**SUBJECT: Fort Calhoun Station Unit No. 1 License Amendment Request (LAR) 05-013,
"Criticality Control During Spent Fuel Cask Loading in the Spent Fuel Pool"**

Omaha Public Power District's Evaluation
for
Amendment of Operating License

“Criticality Control During Spent Fuel Cask Loading in the Spent Fuel Pool”

Figure 2-11

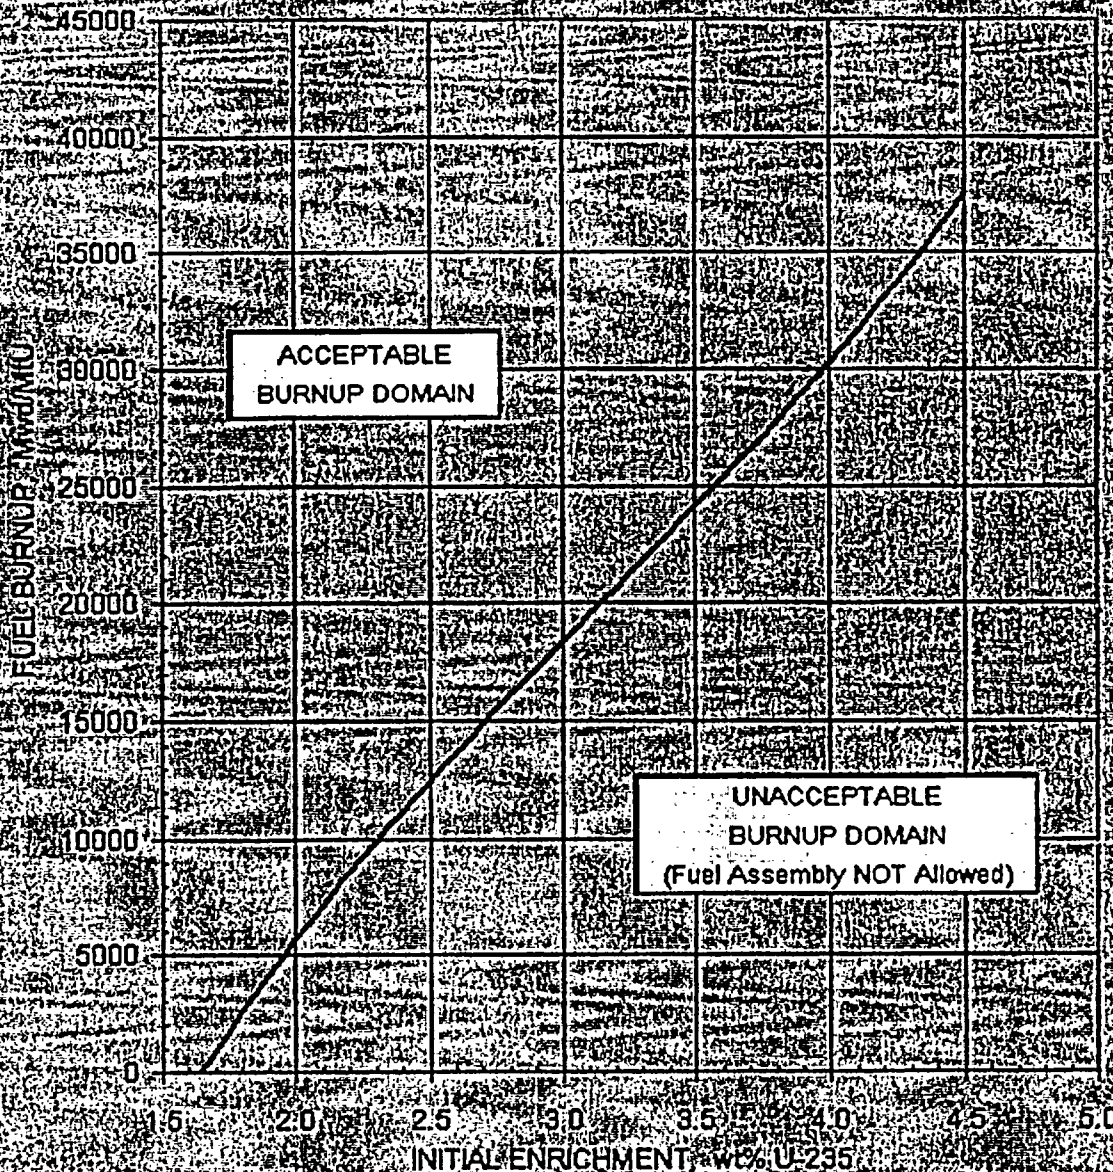
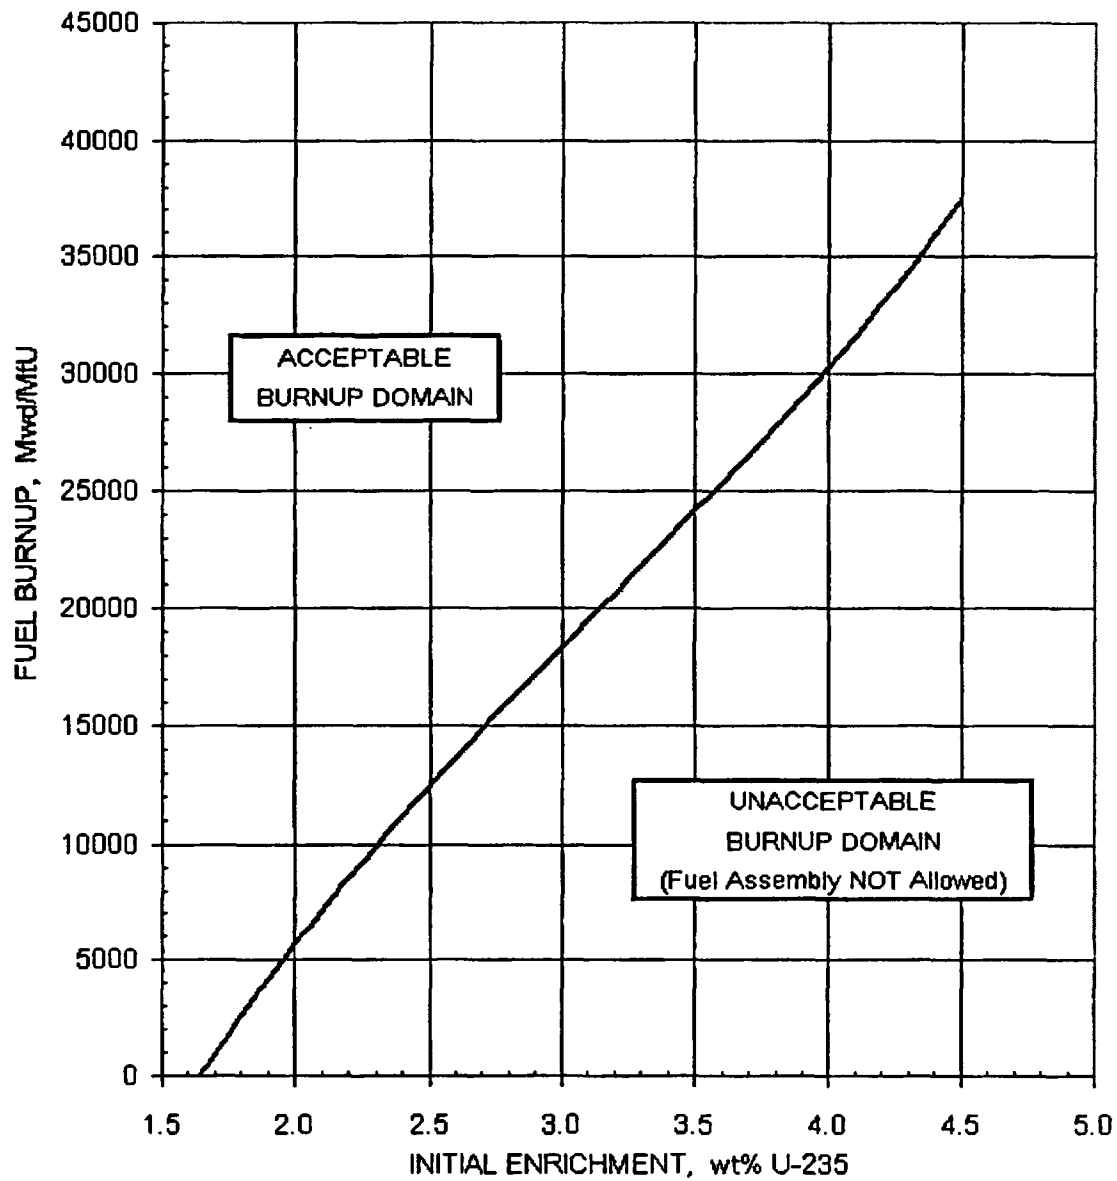
New LCO 2.8.3(6), "Spent Fuel Cask Loading"

This new LCO adds: 1) a new minimum boron concentration limit (800 ppm) for the spent fuel pool during spent fuel cask loading operations and 2) a new burnup versus enrichment curve for fuel assemblies located in a spent fuel cask in the spent fuel pool. New bases for new LCO 2.8.3(6) have been created and are included for information.

- (1) The spent fuel pool boron concentration shall be >800 ppm, and
- (2) The combination of initial enrichment and burnup of each spent fuel assembly located in a spent fuel storage cask in the spent fuel pool shall be within the acceptable burnup domain of Figure 2-1.1.

- (1) The spent fuel pool boron concentration shall be ≥ 800 ppm, and
- (2) The combination of initial enrichment and burnup of each spent fuel assembly located in a spent fuel storage cask in the spent fuel pool shall be within the acceptable burnup domain of Figure 2-11.
